ADDENDUM NO. 1

PROJECT NAME: NE Soccer & Tennis Complex- General Construction
UNL PROJECT NUMBER: C909P101/ 10186
BID INVITATION NUMBER: 2339-14-7200

CONSULTANT: RDG Planning & Design
ADDRESS: 301 Grand Avenue
Des Moines, IA 50309

DATE OF ISSUANCE: March 27, 2014
DATE OF BID OPENING: Tuesday, April 8, 2014
3:00 PM CT

D2 **WALL TYPE W12**
1 1/2" = 1'-0"

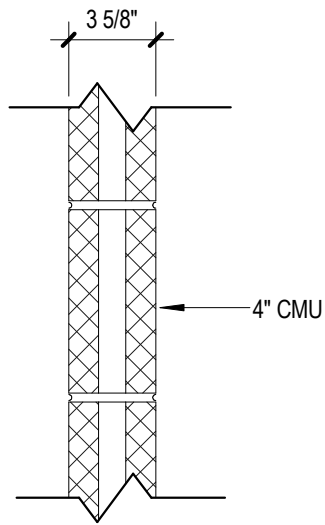
- A. Drawing D2: Add 4” CMU wall type (Wall Type W12). See attached Drawing AD1-A02.
- B. Drawing D5: D6/A0.11: Show plywood pattern at sheathing where note indicates 5/8” FRT PLYWOOD.

1 INDOOR TENNIS/ SUPPORT BUILDING FLOOR PLAN LEVEL 1 - AREA B
 1/8" = 1'-0"

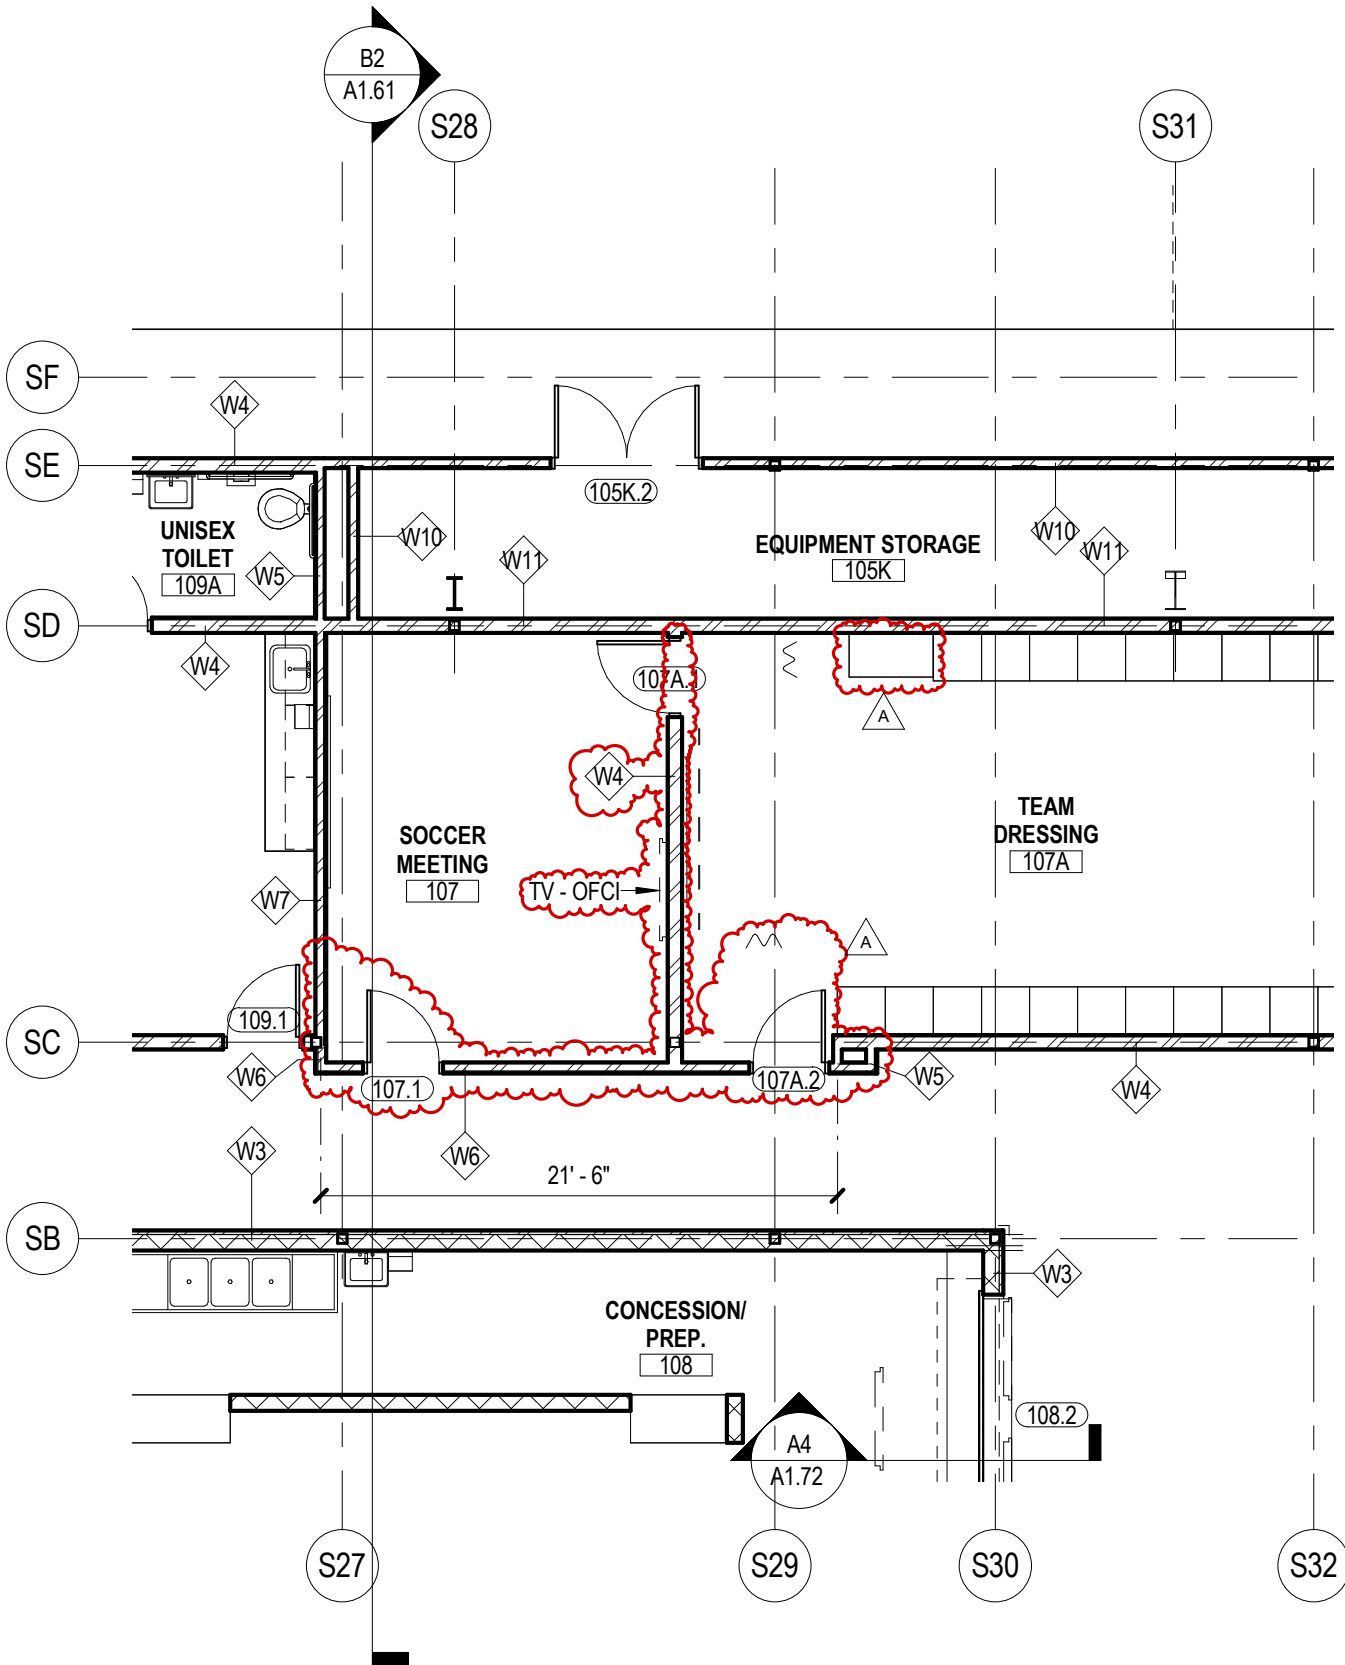
- A. Revise walls, doors and casework in vicinity of rooms 107, 107A, and 109. Also see items in this addendum for Drawing A1.23. See attached drawing AD1-A03.

**ENLARGED PLAN @ SOCCER,
TREATMENT & WOMEN'S TENNIS**

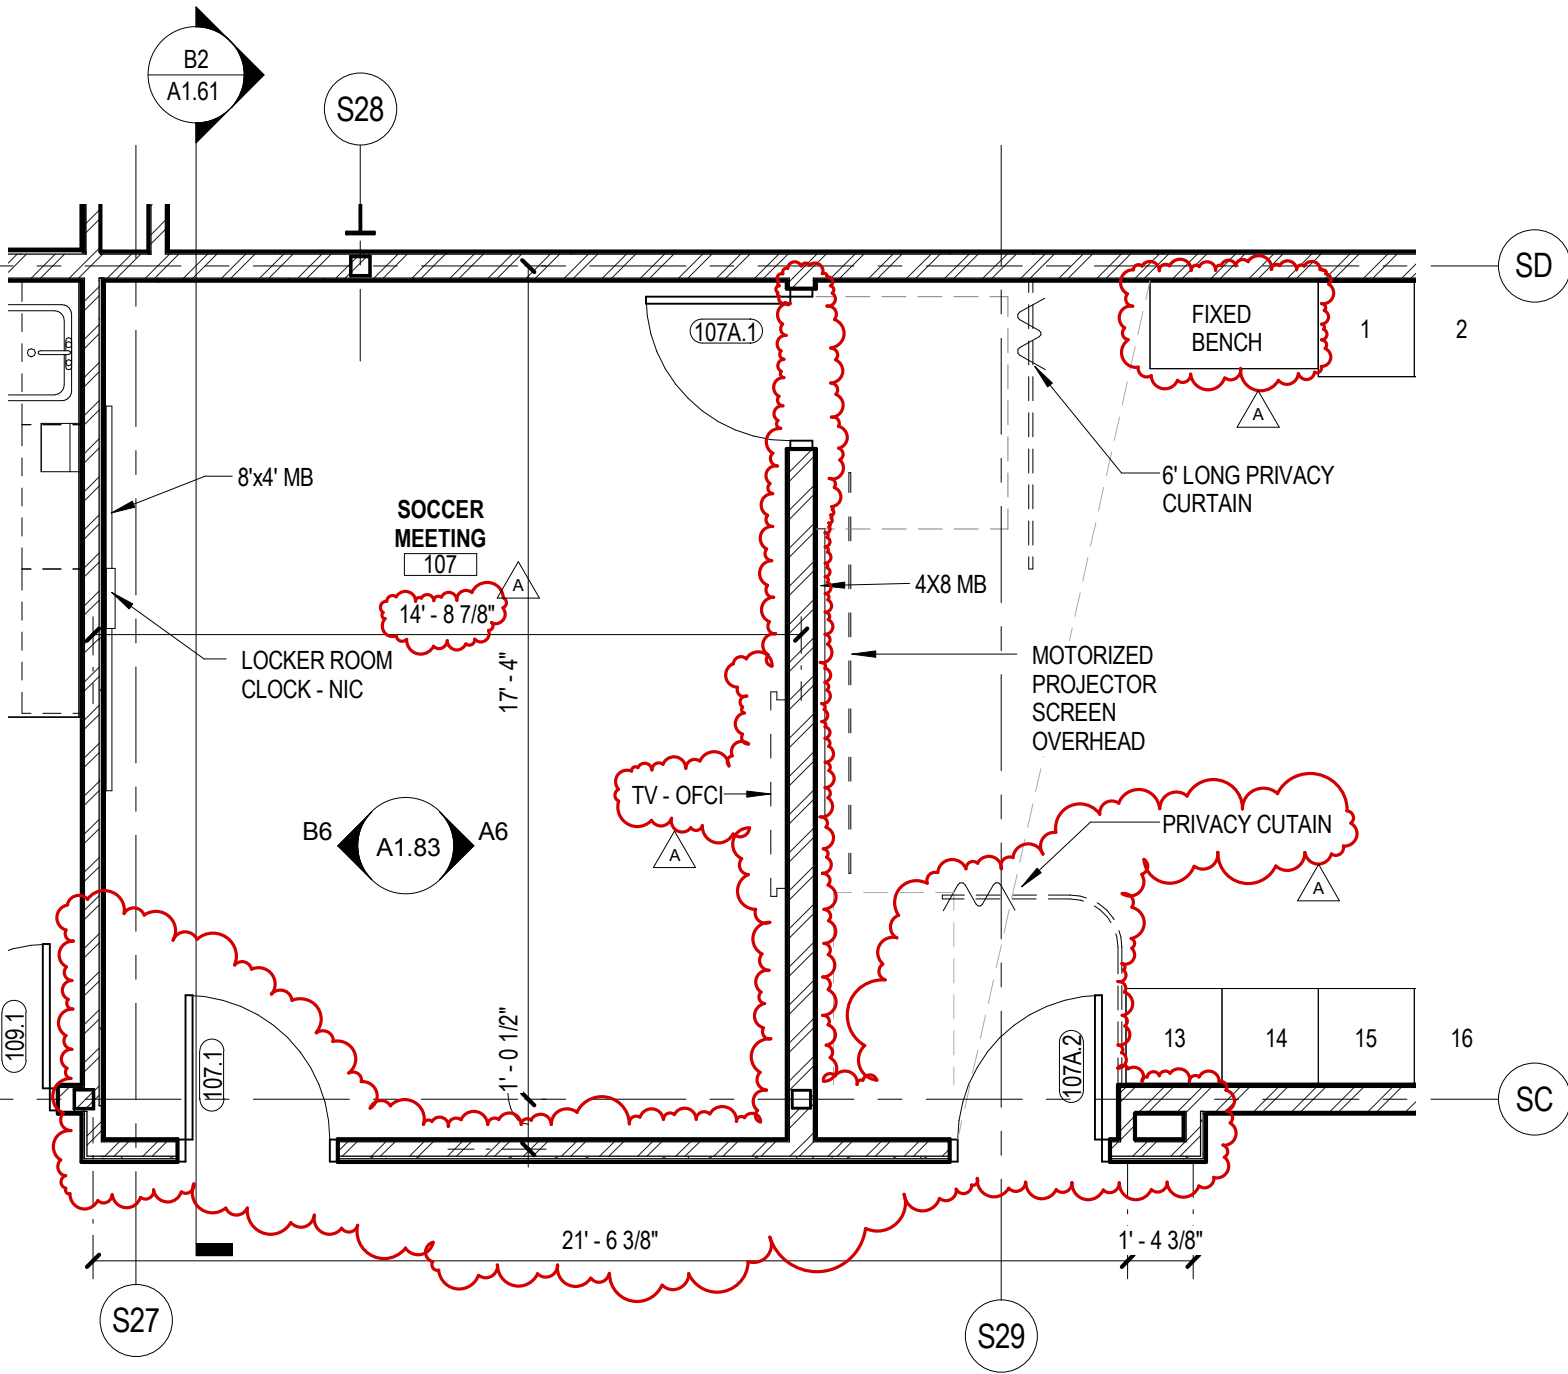
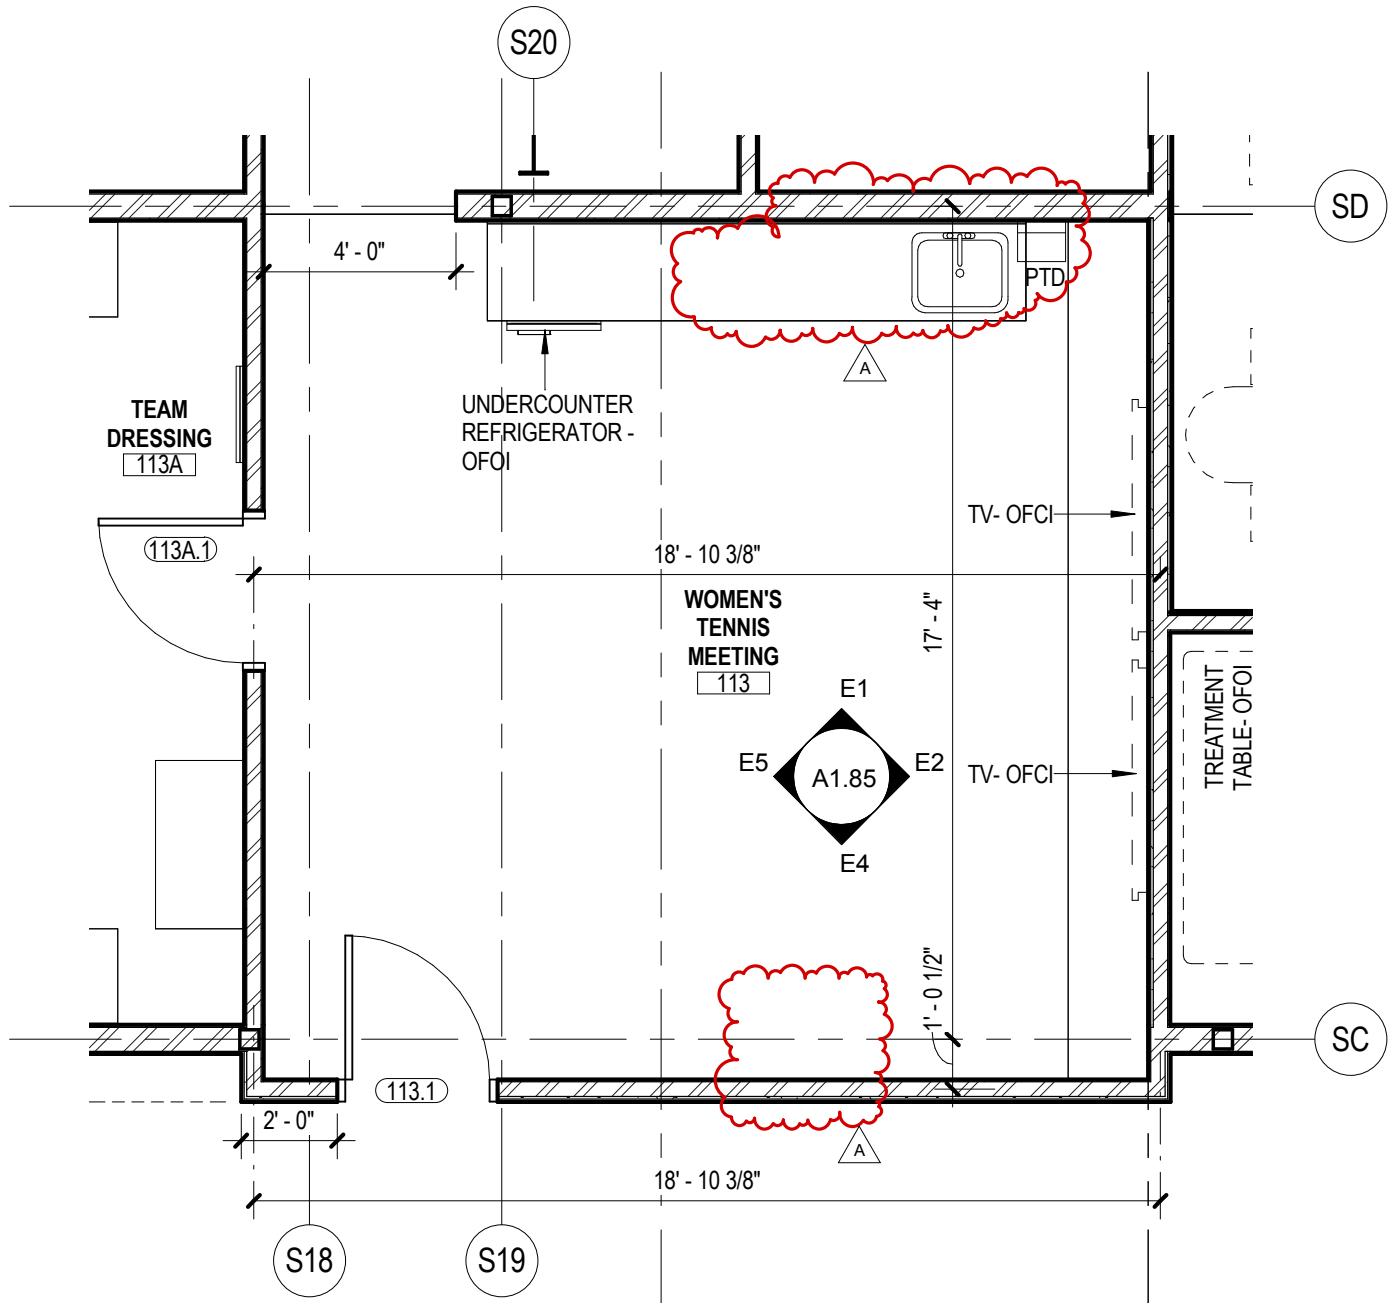
- 1. Drawing D1- see attached drawings AD1-A04 and AD1-A05:
 - a. Women's Tennis Meeting 113: Omit study counter. Relocate sink and paper towel dispenser
 - b. Soccer Meeting 107: Omit door 107.2. Move Door 107.1.
 - c. Team Dressing 107A: Add Door 107A.2. Revise wood paneling. Omit 2 lockers and revise locker layout. Relocate changing bench. Add privacy curtain. Change west wall to wall Type W4 (6" studs).

C1 ENLARGED PLAN @ MENS TENNIS MEETING 113
 1/4" = 1'-0"

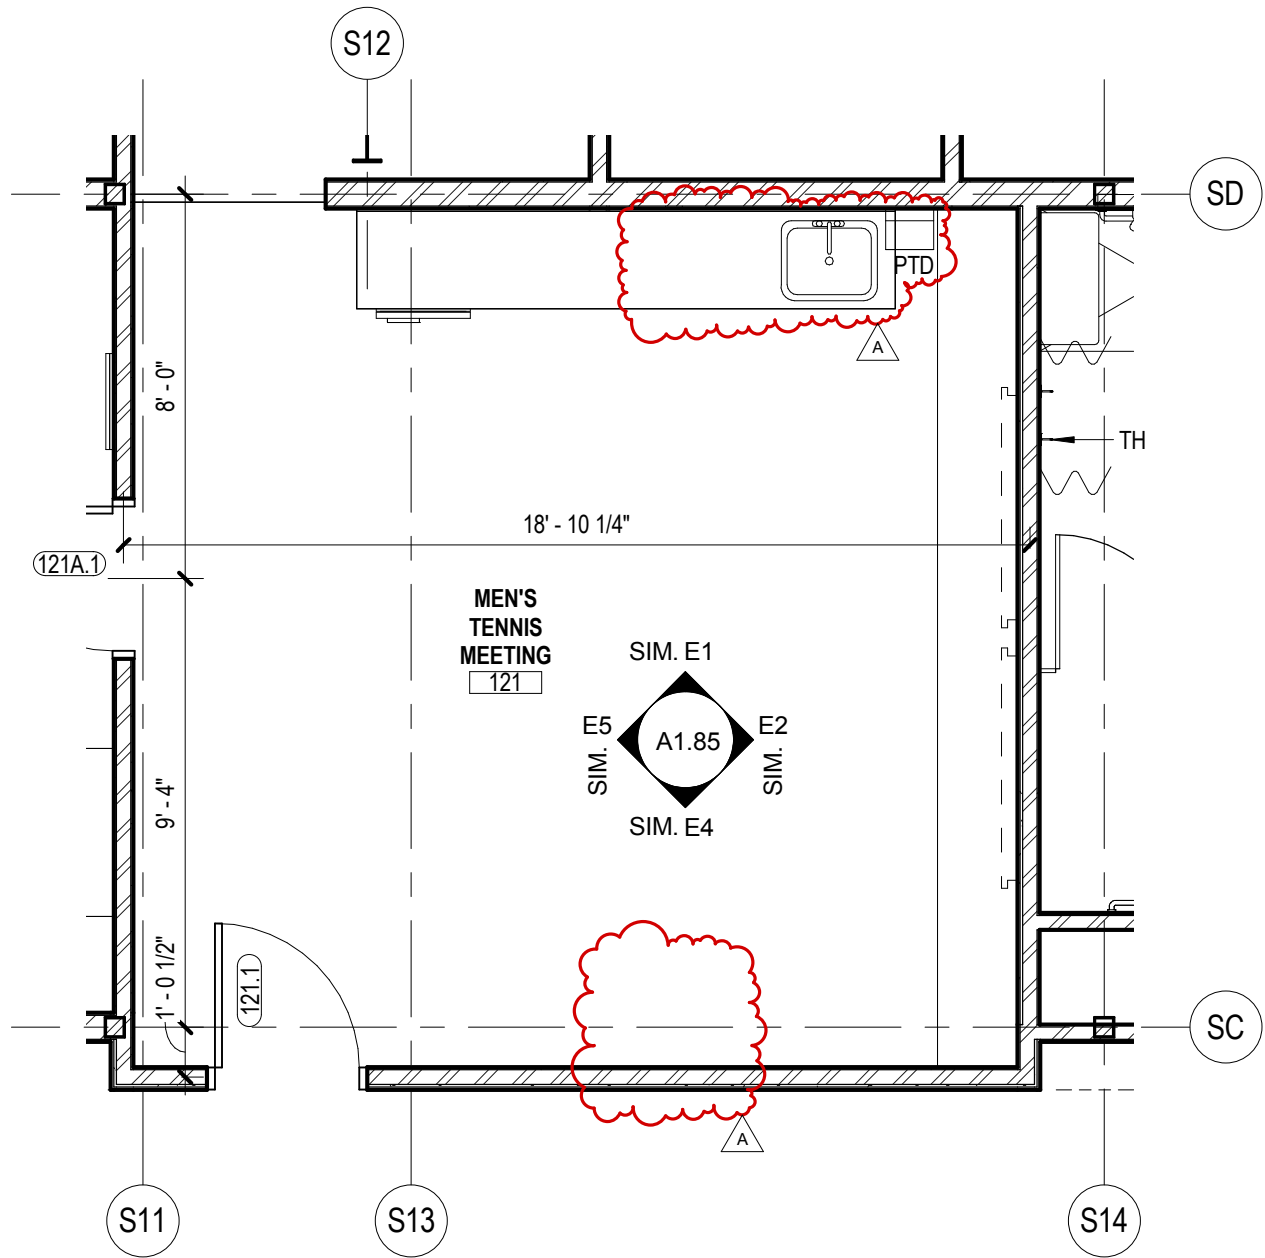
- A. Drawing C1:
 - 1. Men's Tennis Meeting 121: Omit study counter.
 - 2. Move sink and paper towel dispenser closer to match location in Women's Tennis Meeting 113.
- B. Drawing A1:
- C. Delete dashed lines next to Doors 221.1 and 223.1 (correct drawing error).

E2 WALL AT EXTERIOR MULLION
 1 1/2" = 1'-0"

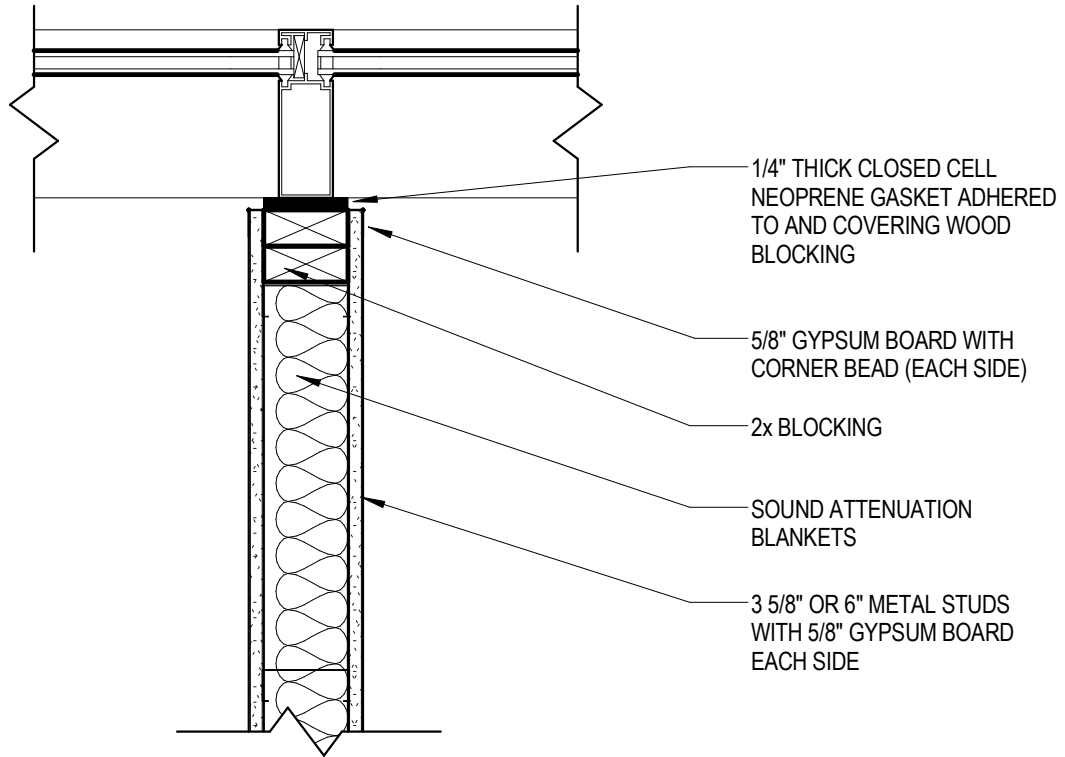
- A. Drawing A4: Omit (Study Counter omitted).
- B. Drawing A5: Drawing title to read "FIXED CHANGING BENCH-ACCESSIBLE."
- C. Drawing A6: Drawing title to read "FIXED CHANGING BENCH-ACCESSIBLE @ GYP. WALL."
- D. Drawing D6: Add detail callout for E2/A1.41 where the wall meets the south exterior mullion.
- E. Drawing E2: Add drawing for Wall at Exterior Mullion. See attached drawing AD1-A07.
